BAR Meeting  
November 16, 2011

**ISSUE:** Addition and Alterations

**LOCATION:** 804 South Lee Street

Illustration of Existing and Proposed Footprints

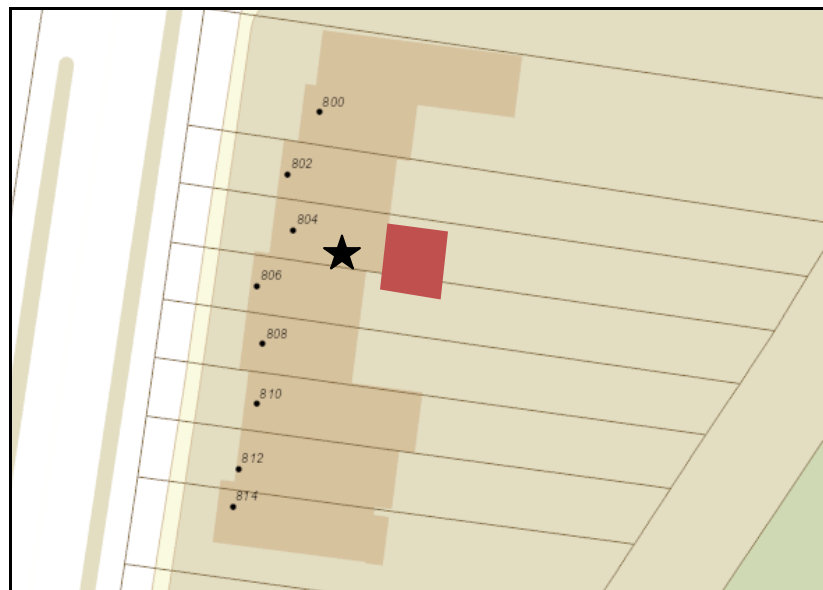
While there is precedent for approving large rear additions on this block of South Lee Street, Staff believes that some of them were more successful than others. There are currently, rear additions on this block at 800, 810, 812 and 814 South Lee Street (see illustration below). The side/rear addition at 800 South Lee Street is the largest, as it is four-stories in height and five bays deep. This addition although appropriately scaled from the front elevation, is significantly large as viewed from the Jefferson ROW and the Federal Parkland. Staff does not believe this is a successful example of a side/rear addition onto a Yates Garden townhouse. 812 and 814 are a good comparison for the subject case as they each have a three-story addition, with 812 also fashioning an attic level dormer. Based on footprint measurements obtained in the City's GIS<sup>1</sup>, 812 and 814's additions are approximately 16 and 20 feet deep respectively, which is consistent with the applicant's 20 foot proposal (illustrated in red). Staff does feel that both of these additions are compatible and do not negatively impact the historic streetscape or existing development patterns.

Staff does acknowledge the proposed addition will have an impact on the applicant's flanking neighbors, as they currently do not have rear additions. Additionally, the proposed addition will be visible from the Jefferson Street ROW extension and the Federal parkland (Jones Point Park) located behind the subject lots. However with the natural vegetation and grade differentials, it will not be a dominant element in the landscape. Upon a recommendation of Staff, the applicant e-mailed the proposed drawings to all the neighbors along this blockface. To date, neither Staff nor the applicant has received any negative feedback regarding this application.
